This is my testimony concerning the proposed Zelman#1 injection well to be located off Tower Lane, in Brady Twp., Clearfield Co., Penna. 15801. (Permit App. # PAS2D020BCLE).

RE: UIC Permit PAS2D020BCLE (Windfall/Zelman 1)

Re: Underground Injection Control Permit Number PAS2D020BCLE
Public Hearing Testimonial

Windfall/Zelman #1 DIW ~ Permit # PAS2D020BCLE

Exhibit #1

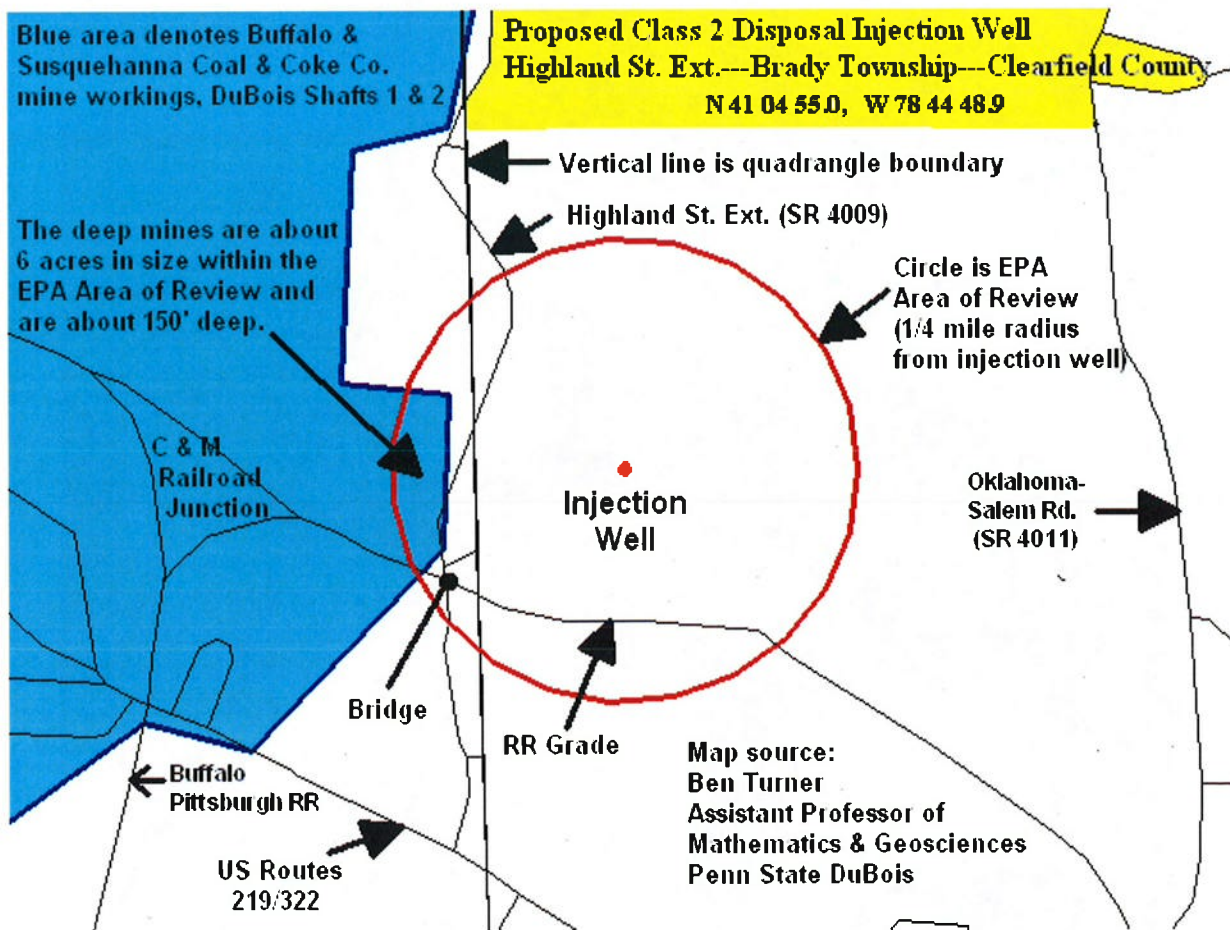
The Windfall permit application is deficient because there is no map included showing the location of subsurface mines within the Area of Review and beyond. There are approximately 6 acres of subsurface mines **within** the western side of the area of review. Maps of these subsurface mines are publicly available from the PA DEP District Mining Operations, California District Mining Office.

These subsurface mines extend for 3 miles and discharge at the DuBois Mall property and into the Sandy Lick Creek. A breach of oil or gas waste into the deep mines could come to the surface and be discharged into the Sandy Lick Creek through the interconnected #2 and #1 Shaft Mines.

The information on Exhibit #1 shows the location of the subsurface mines within the area of review and was obtained from Ben Turner, a Penn State University professor.

Exhibit #2 ~PA DEP Map of Subsurface Mines within Zelman DIW Area of Review

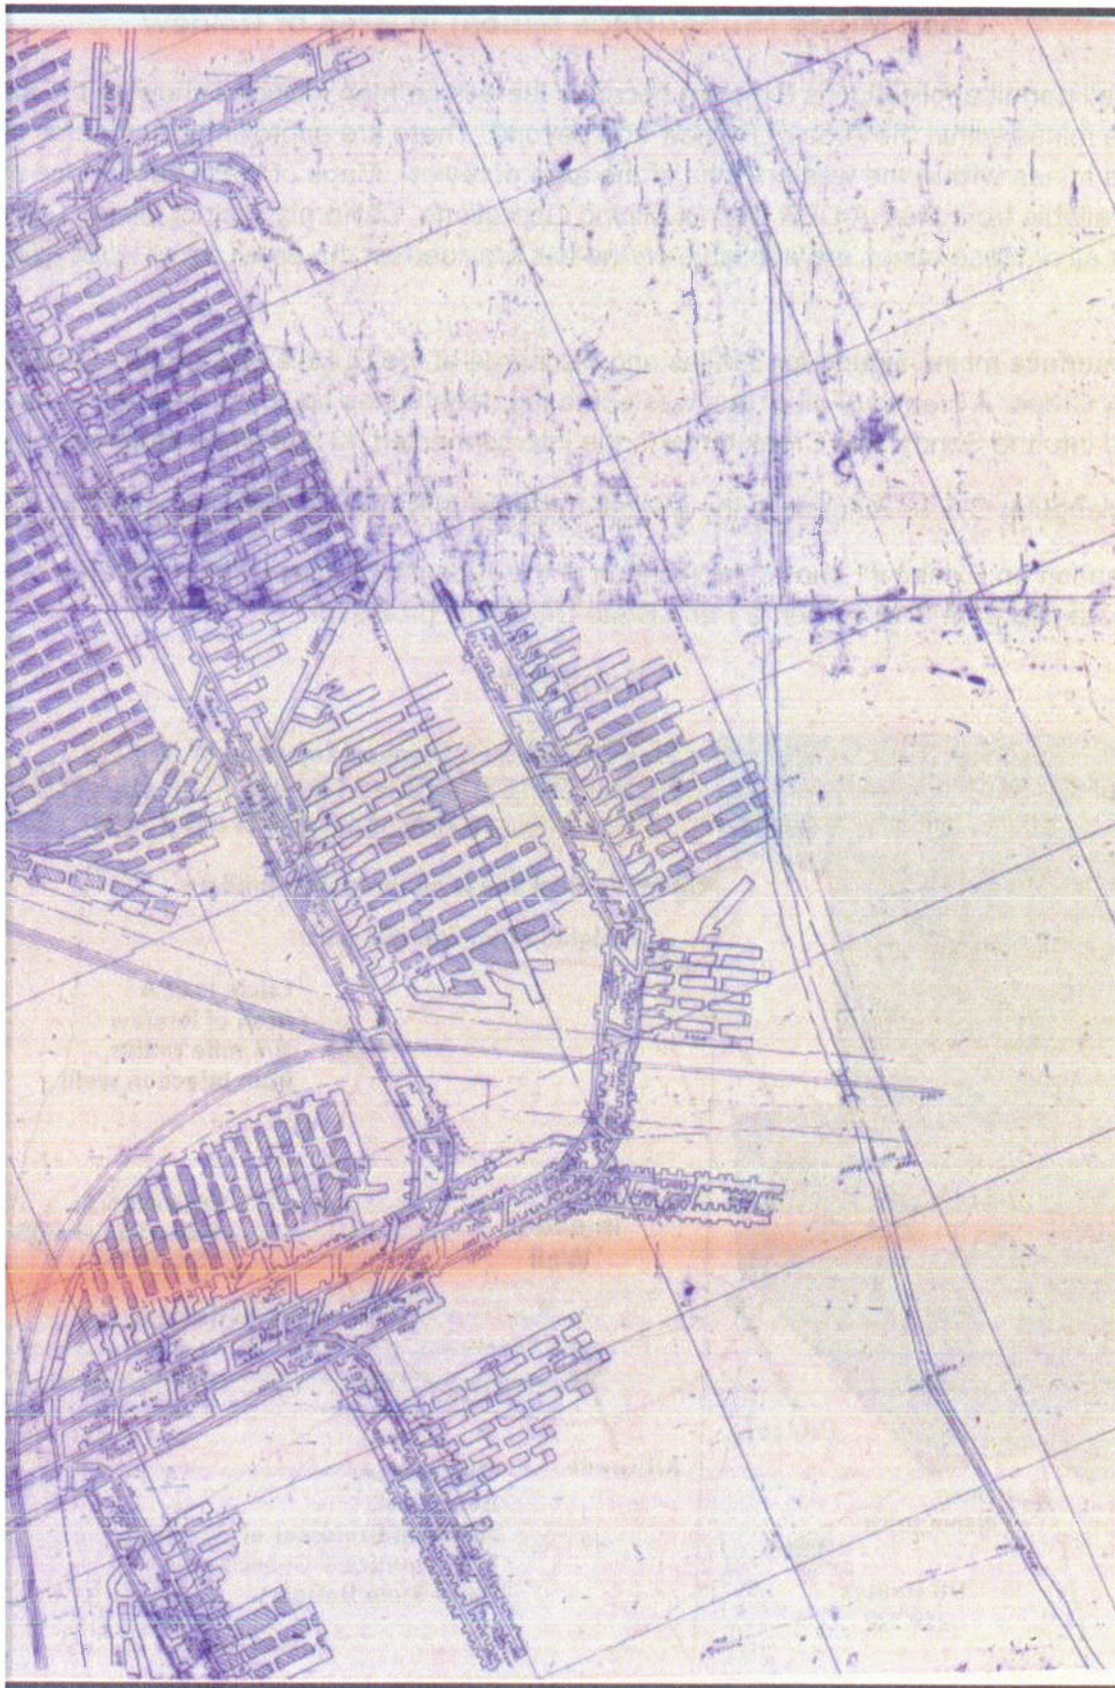
Note the triangular C & M Junction to the west of the Area of Review on both exhibits for bearings.
